TVA-BFN-TS-427

BROWNS FERRY NUCLEAR PLANT (BFN) - UNIT 1 - TECHNICAL SPECIFICATIONS (TS) CHANGE 427 - DELETION OF THE LOW PRESSURE COOLANT INJECTION MOTOR-GENERATOR SETS

Technical Specifications (TS) Change TS-427 Deletion of the Low Pressure Coolant Injection Motor-Generator Sets

FIGURE 4
PROPOSED UNIT 1 ELECTRICAL DISTRIBUTION SYSTEM

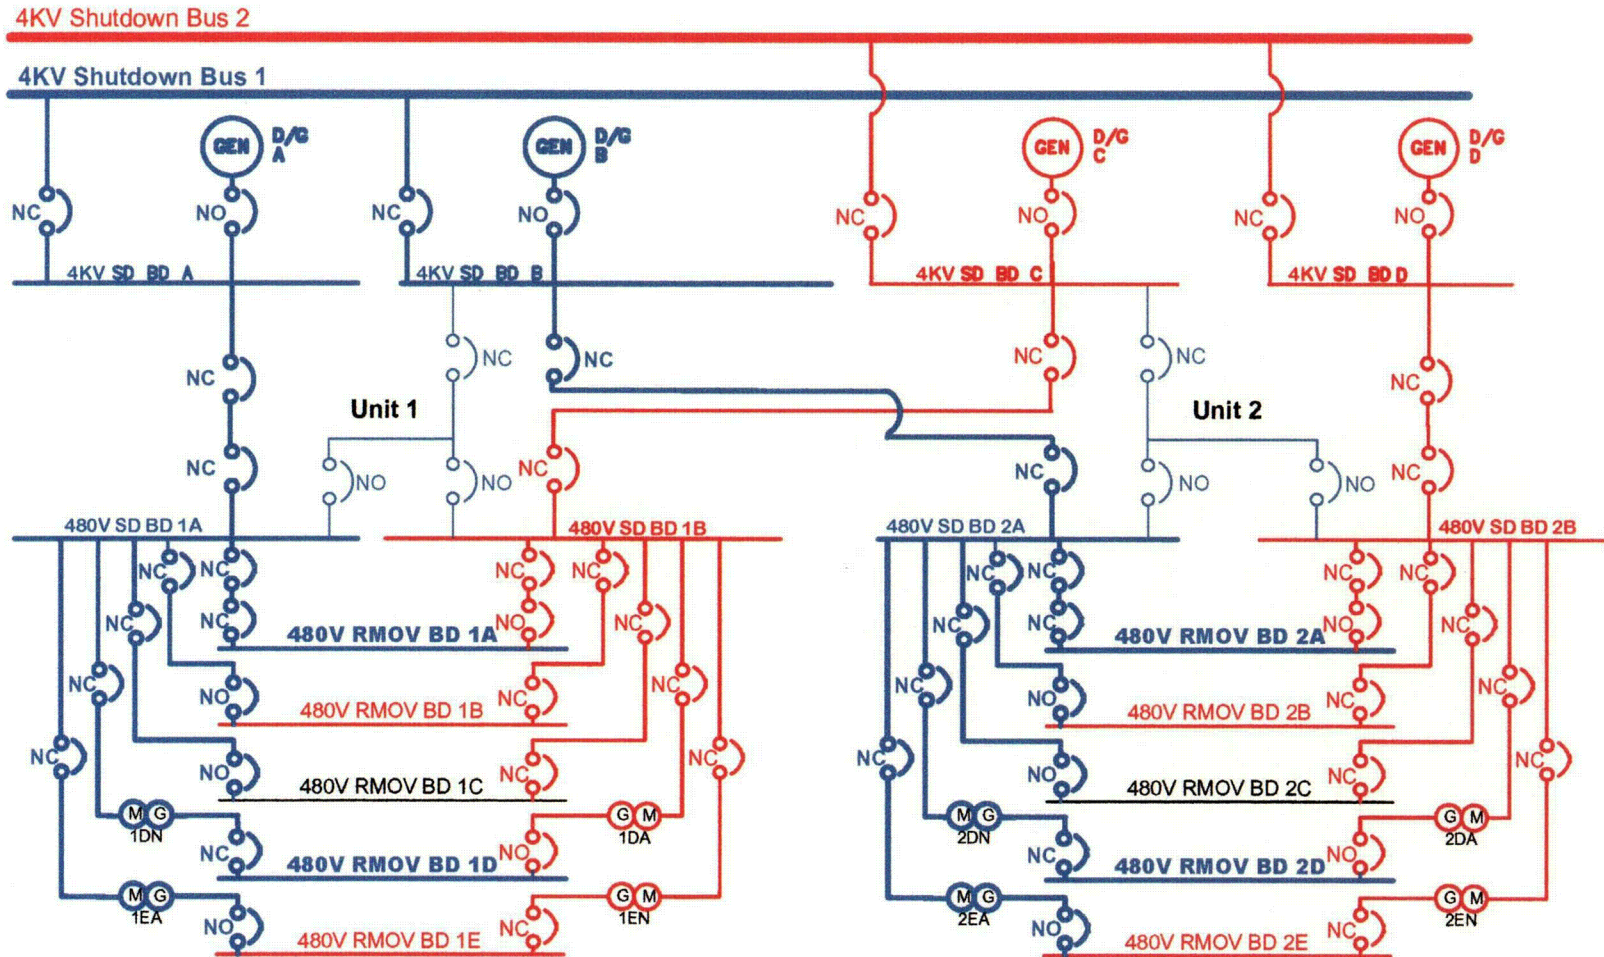
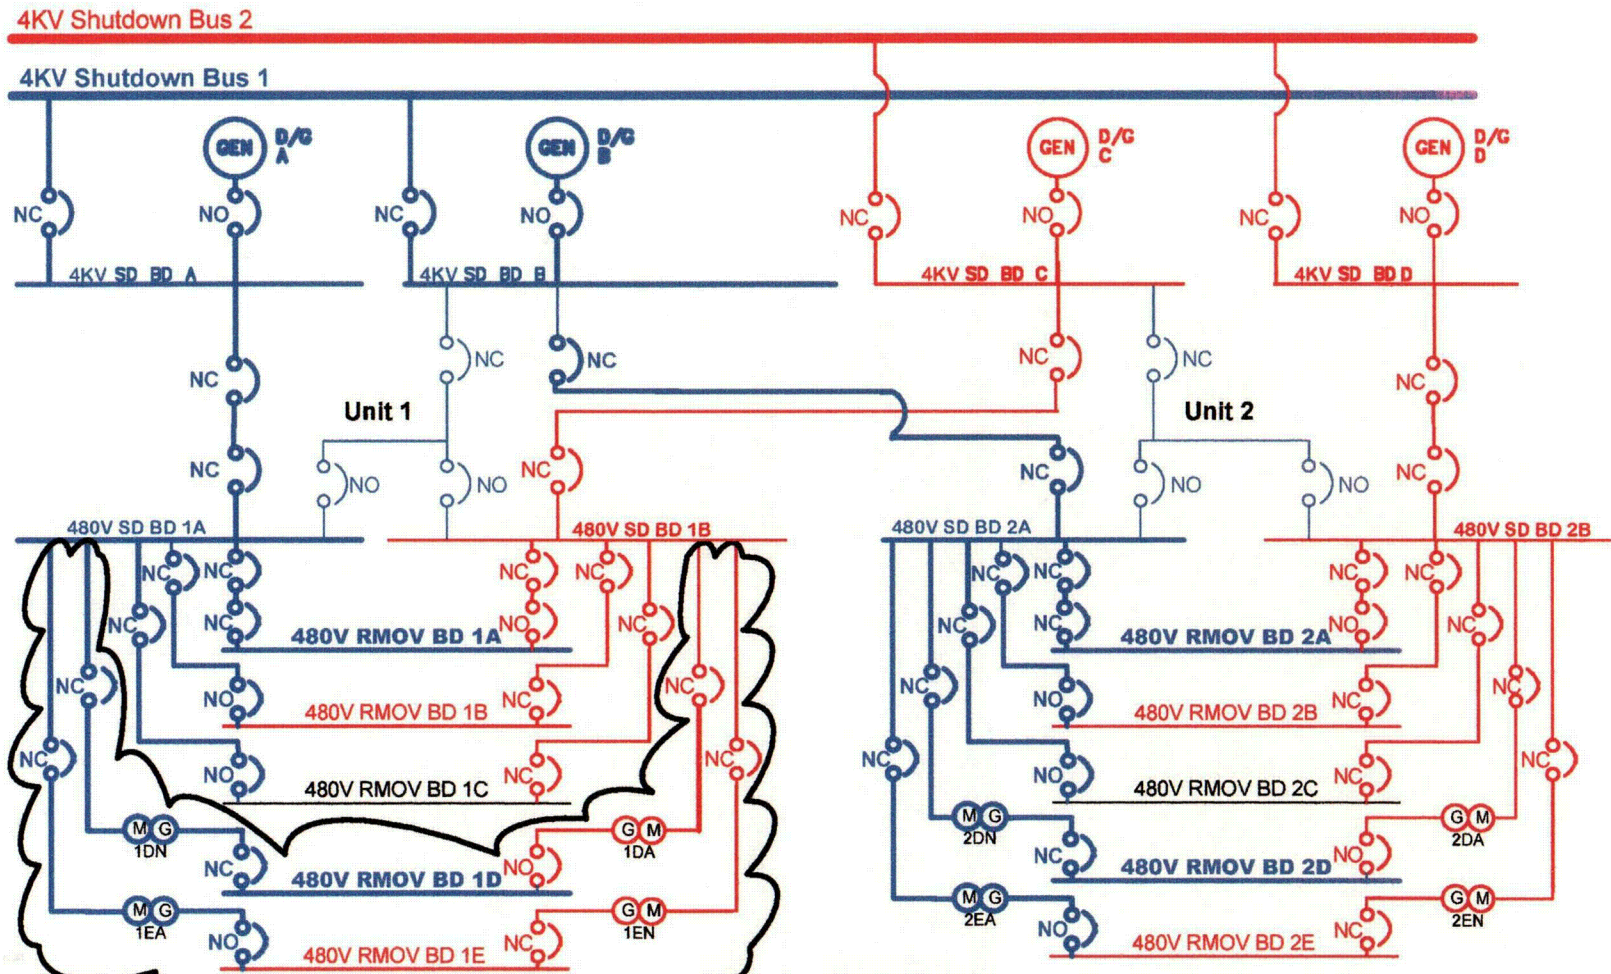
The Unit 1 LPCI Motor-Generator Sets and associated 480V Reactor Motor Operated Valve (RMOV) Boards D and E will be removed from service prior to restart. The Unit 1 equipment being removed from service is shown in Figure 4. There are no proposed changes to Units 2 and 3.

The loads on Unit 1 480V RMOV Boards D and E will be transferred to the respective Division I and II 480V RMOV Boards A and B. 480V RMOV Boards A and B are physically located within the Reactor Building, in a mild environment.
